City of Brisbane

Planning Commission Agenda Report

SUBJECT: **786 Humboldt Road;** R-1 Residential District; Grading Review EX-3-17; Grading Review for 905 cubic yards of soil export to accommodate construction of a new single-family home on a vacant 4,265 square-foot lot with a 28% slope; Derek Vinh, ICE Design Inc., applicant; Zhihui Yang and Feng Yi He, owners; APN 007-432-370.

View southwest from Humboldt Road (Bay tree in upper left corner)

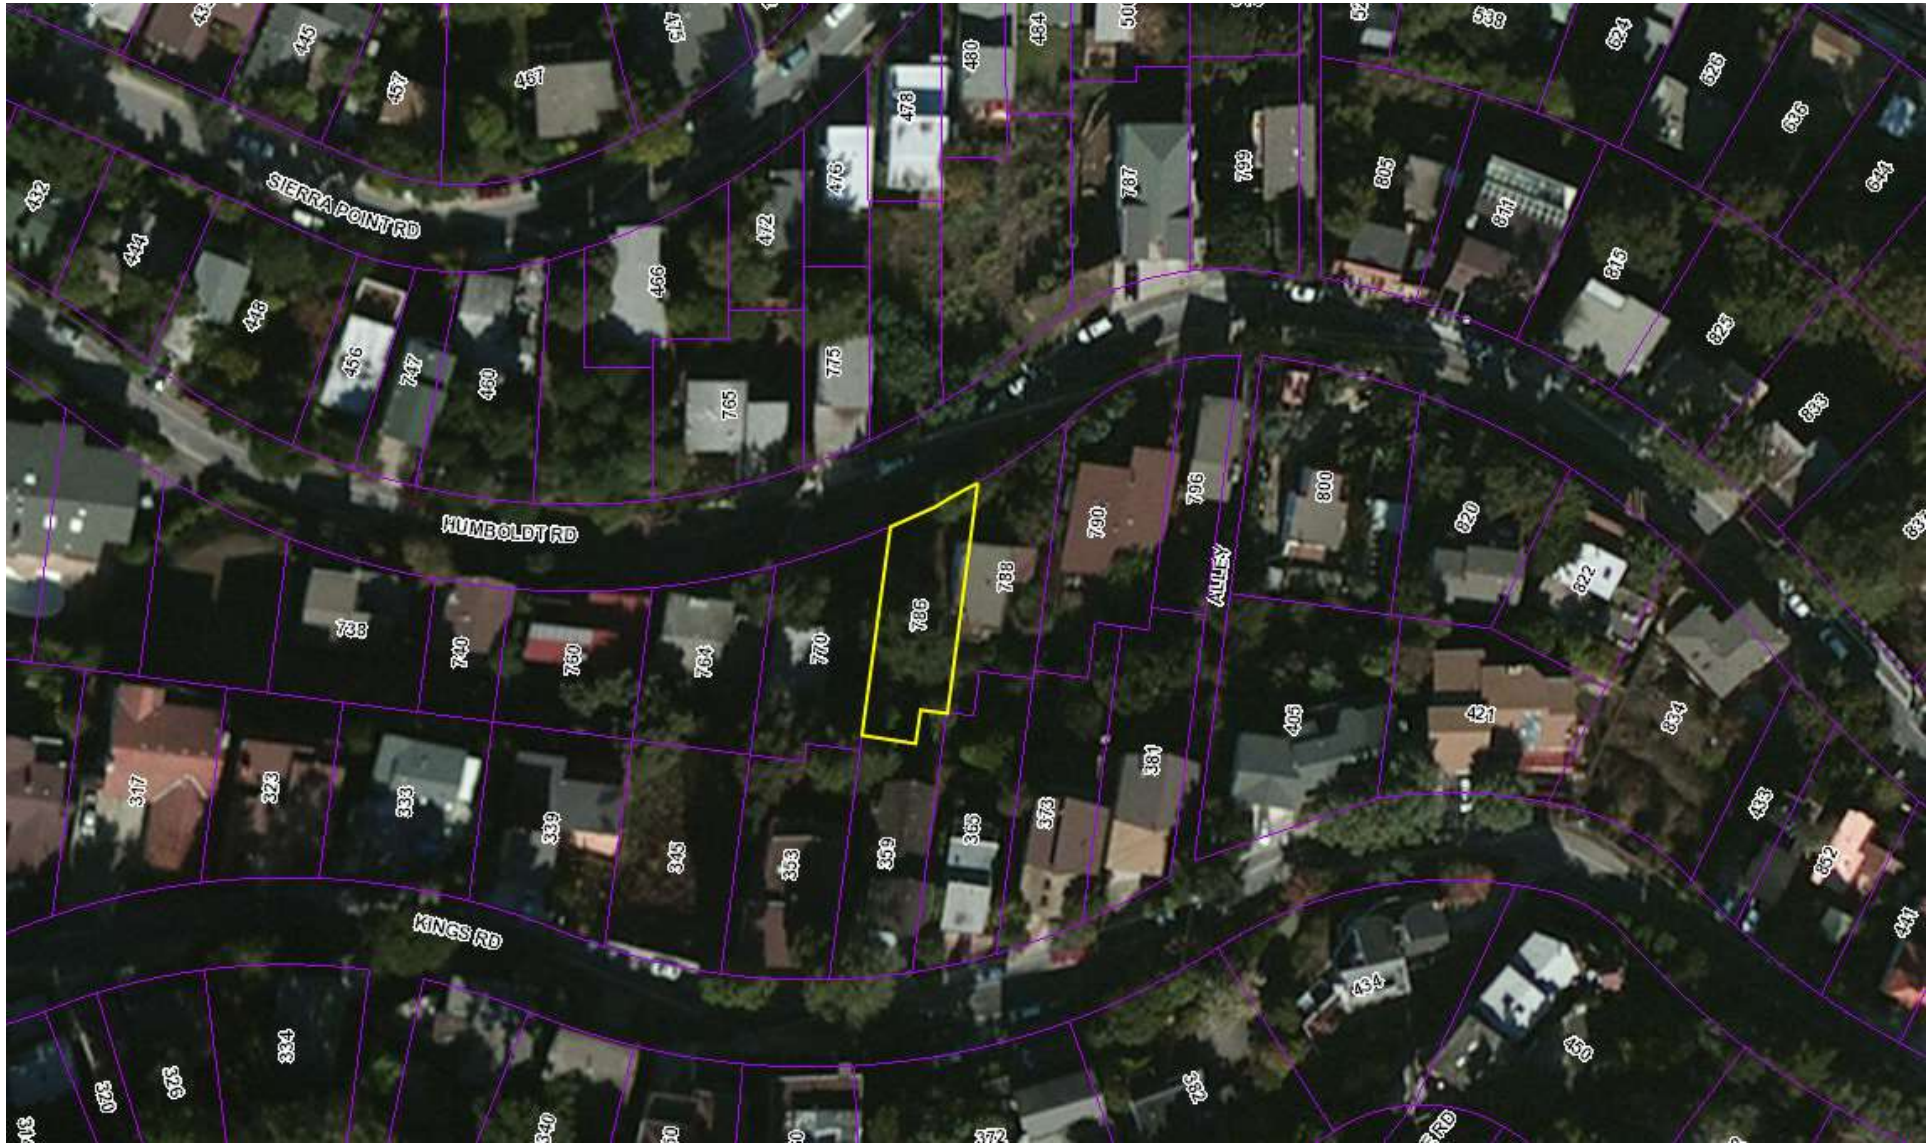
The submitted grading and landscaping plans call for removal of one Bay tree with a trunk circumference of 37.7 inches located in the front yard, and two small fruit trees in the rear yard. The Bay tree is located roughly in the middle of the front yard, approximately 2 ft., 7 inches from the front lot line within the footprint of the proposed driveway. Considering the minimum setbacks required for the structure and minimum driveway width required to accommodate the mandatory off-street parking, removal of the Bay tree cannot feasibly be avoided. Condition of Approval A.2 requires that this tree be replaced with a suitable tree elsewhere on the property, to be identified by the landscaping plan submitted with the building permit application and subject to approval by the Community Development Director.

- Per the submitted project plans, the proposed grading would result in the removal of a Bay tree with a trunk circumference of approximately 37 inches located within the front yard. Condition of approval A.2 requires a suitable replacement tree be identified in the landscaping plan submitted with the building permit application, subject to approval by the Community Development Director.
